Parking Brake or Cruise Control Malfunction Message With DTC C13B0

Service Category Brake

Section Brake Control/Dynamic Control System

Figure 3. Location of Authorized Modifications Label on 2018 – 2020 Camry

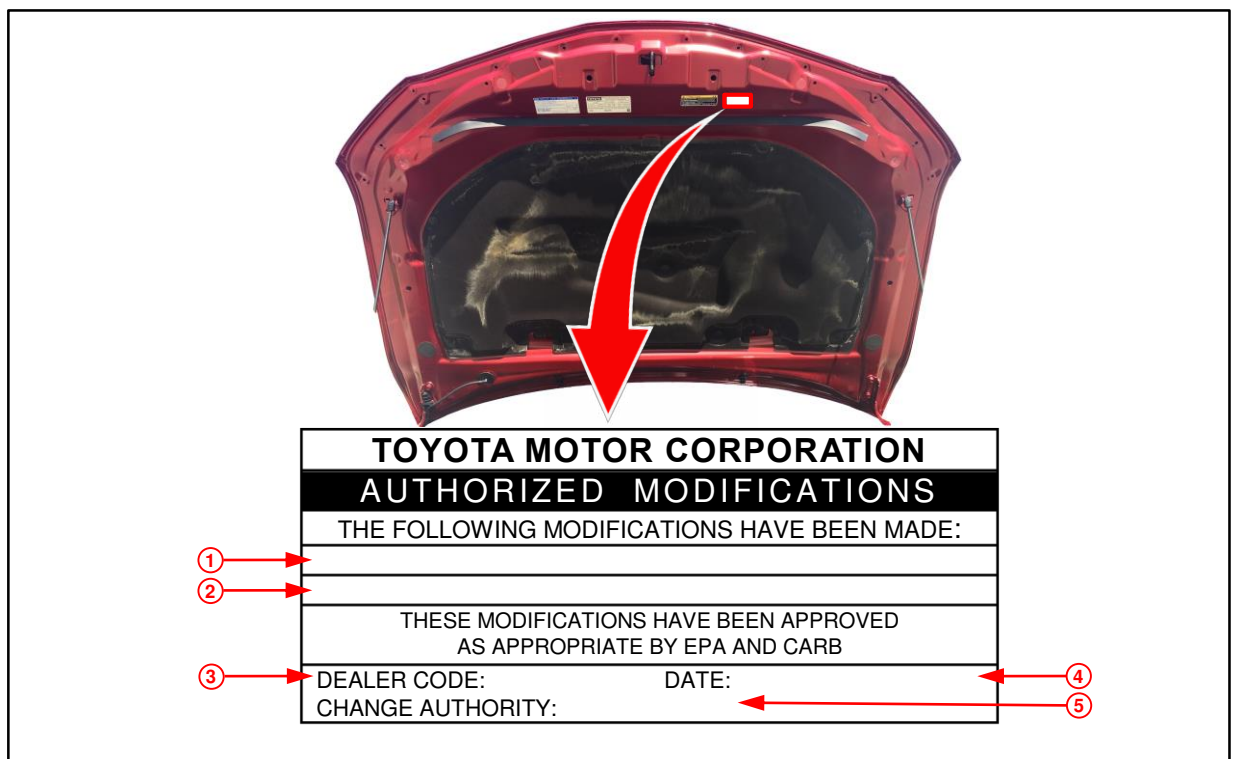
3. Use Techstream to confirm if the skid control ECU calibration has been updated and check for the Authorized Modifications Label affixed to the vehicle in the location shown below.

5. Prepare and install the Authorized Modifications Label.
 - A. Using a permanent marker, enter the following information on the label:
 - ECM (PCM) part number [*Refer to the **Parts Information** section for the **NEW PART NUMBER***]
 - Calibration ID(s) [*Refer to the **Calibration Information** section for the **NEW CALIBRATION ID***]
 - Dealer Code
 - Repair Date
 - Change Authority [***This bulletin number***]
 - B. Install the Authorized Modifications Label onto the vehicle at the location shown in Figure 3. The Authorized Modifications Label is available through the MDC, P/N 00451-00001-LBL.
6. Test-drive the vehicle to confirm proper operation.
